Re: VARIANCE REQUEST ROBERTS PROPERTY 1019 MAGOTHY AVENUE ARNOLD, MD 21012 2023-0202-V

PROJECT NOTIFICATION APPLICATION

CRITICAL AREA REPORT

CONFIRMATION OF PRE-FILE MEETING

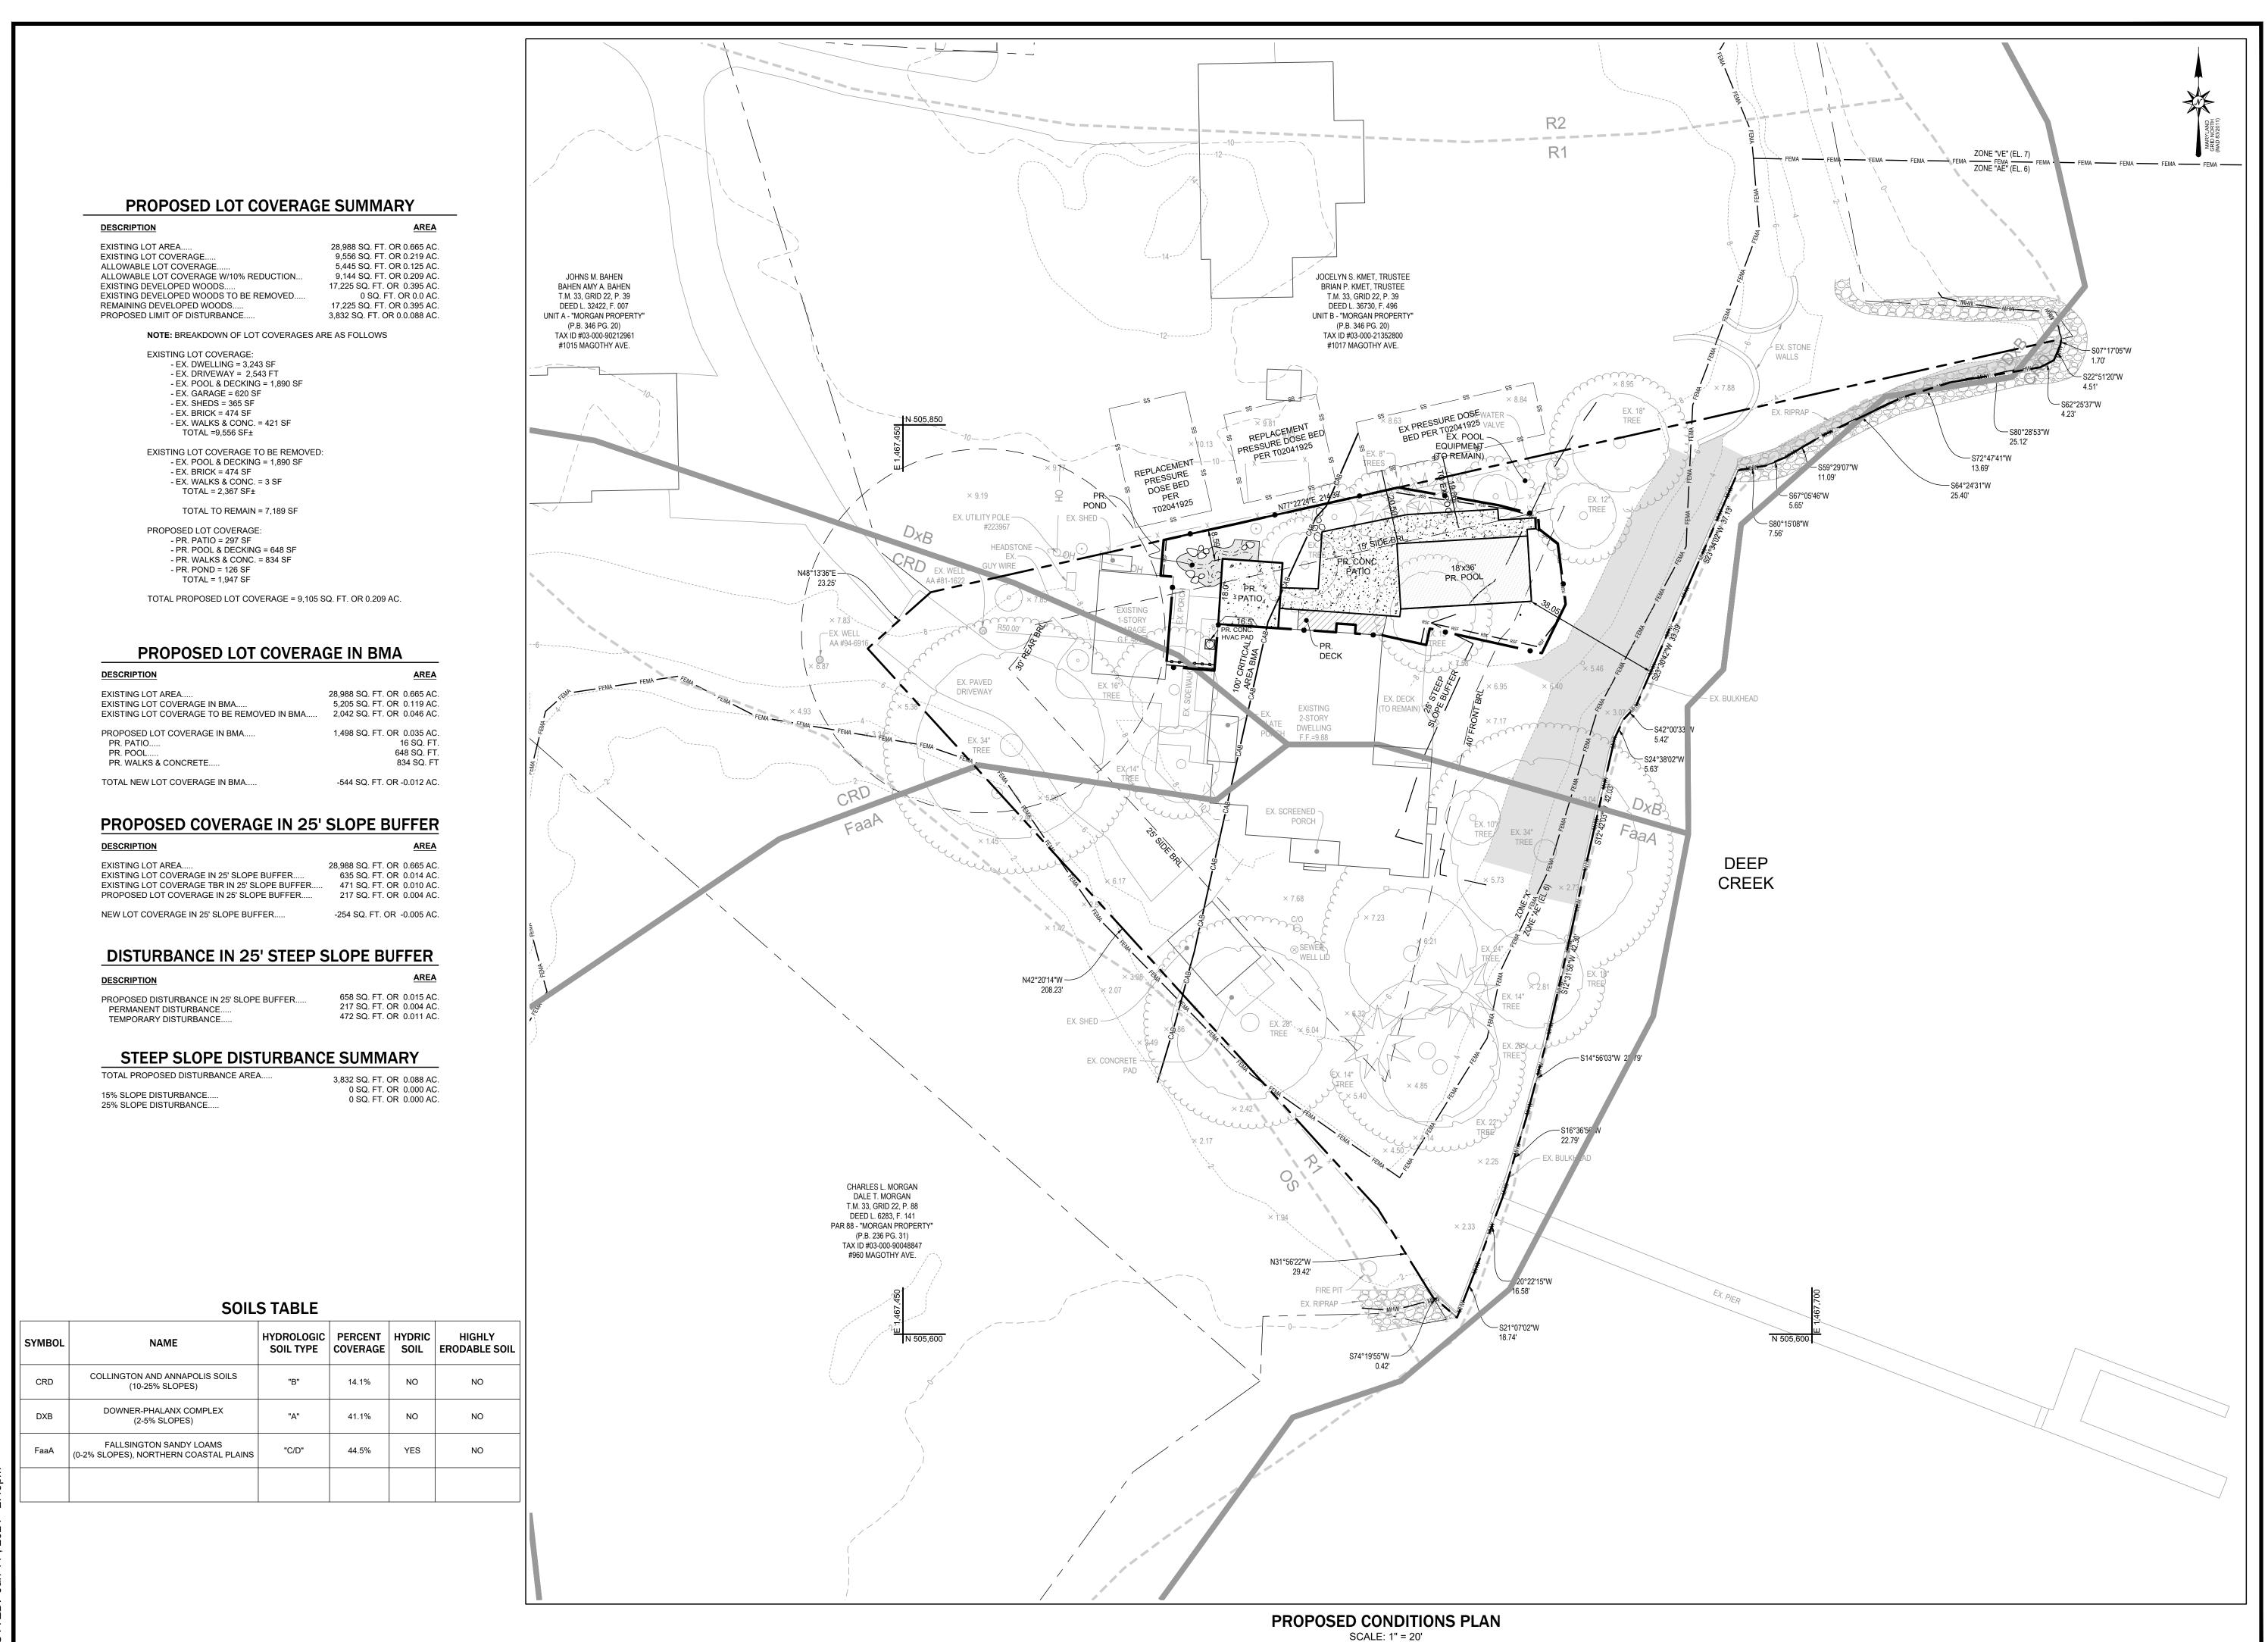
This letter is also to reflect changes to the site plan. The Anne Arundel County Health Department indicated that the proposed pool, porch addition and walls for the pond are too close to the neighbors (1017 Magothy) existing septic system, which is located 5' from the common property line. This issue required design changes to the plan in order to meet setback. Firstly, the proposed porch has been eliminated and a patio is proposed in its place. No septic setbacks are necessary for this feature. Secondly, the wall around the pond has been removed, it will be constructed at grade

level. Thirdly, the new pool was sited closer to the neighbors septic than the existing pool. The pool has been rotated and shifted to meet the required setback. The site numbers have been slightly reduced with this change, and the site plan reflects these changes.

- 1) new lot coverage nearer to the shoreline than the principal structure for pool.
- 2) side lot line setback variances for pool (5 feet) and porch (7 feet) require 15 feet
- 3) front lot line setback variance of 12 feet for pool require 50 feet

Zoning Division - Must provide evidence a 18 foot by 36 pool represents the minimum variance necessary to afford relief.
